LISTED NOTIFICATION

Wilby Barns - Timber Replacement and Wall Repair - Part One

Wilby Manor, Wooten Green,
Wilby, Suffolk, IP21 5LB

Wilby Barns – Wall Repair and Timber Replacement

To record the events, the barn has been divided into seven sections:

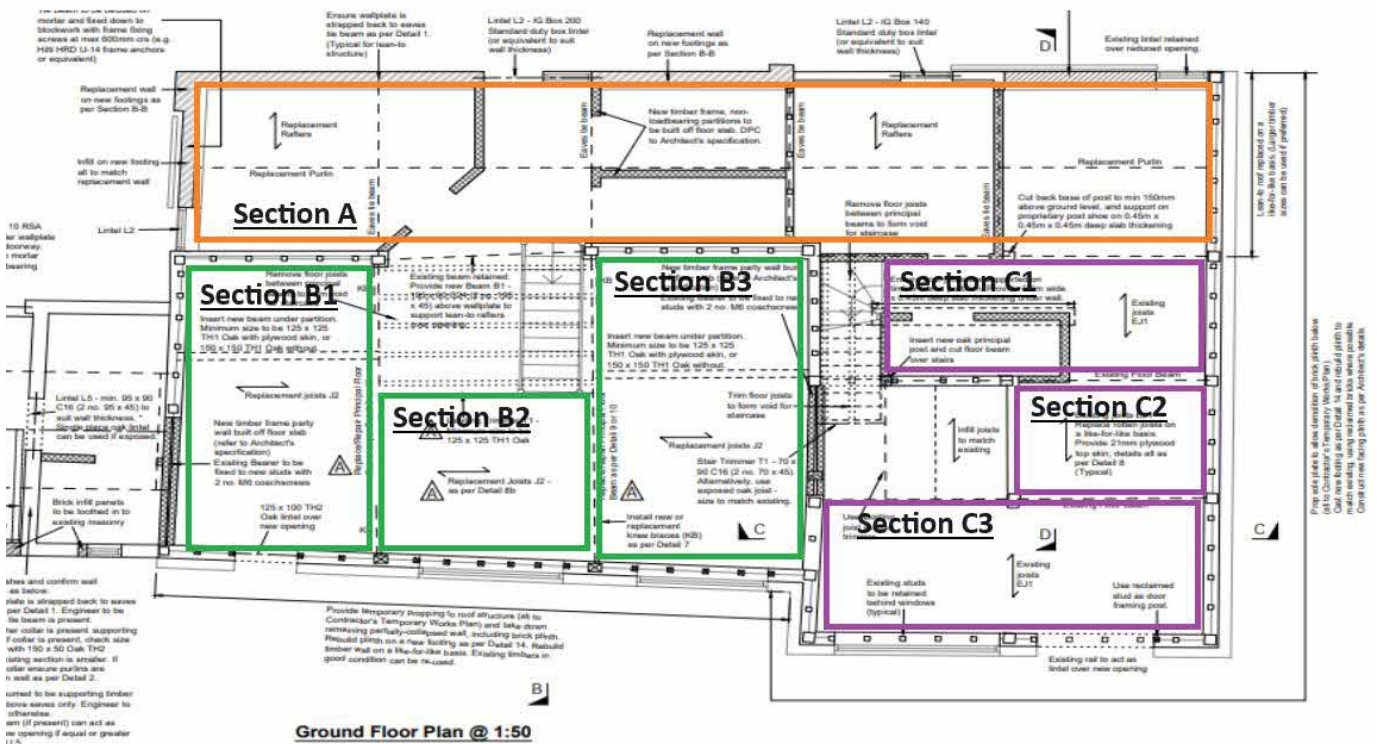
1. Existing Floor Joists - Now that the building has been stripped it is noted that the floor joists are rotten in a large portion of the site and a like-for-like replacement will be needed - review size required of replacement timbers - Action by Caryn from Adam Power

2. General timber replacement - As noted on engineers drawing, like-for-like replacement will be required as and when identified - further inspection required by JB when access available, but we have enough information to order some of the timber for the ground and first floor - Action by Jason Banham (Subgero)

3. Front painted wall - Wall foundation is too shallow and the extent and cost of underpinning will make this a really expensive and time-consuming option, it was discussed and agreed that we would look to take down the white painted brickwork and rebuild the wall with a new foundation, endeavouring to use the existing bricks, Mortar this will also allow the installation of a roof plate as current one needs replacement - we believe that having this wall looking like red brick and not painted is in keeping with the original thoughts , and rebuilding the wall is best and easiest solution - Action by Jason Banham (Subgero)

4. Summary - The extent of timber repairs will be significantly more than tender following the exposure of areas not previously seen by either the structural engineer and the architect .They have agreed that Jason's assessment of what is required to be replaced and what can stay and be used is correct, although we don't have full access to the roof areas and also when timbers are cleaned/exposed there may be more rot to deal with - Mike Manning (Subgero)
